**DATE:** 07.15.2015  
**TO:** ProTrak  
**FROM:** Bill McDow  
Transportation Planning

■ **SMITHFIELD’S BAR-B-Q 17<sup>TH</sup> ST [TRC Plan Review]**

↻ Initial Review Note ↻

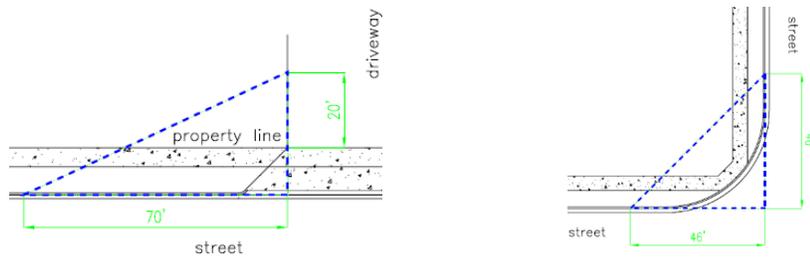
1. The first existing driveway on the 60’ access easement is located within 75’ from the edge of pavement for S. 17<sup>th</sup> Street. This driveway may be impacted by review of the Driveway permit.
2. The driveway curb return must be at least 6.5’ from intersecting property lines. [Chapter VII, C, Table 4 CofWTSSM]
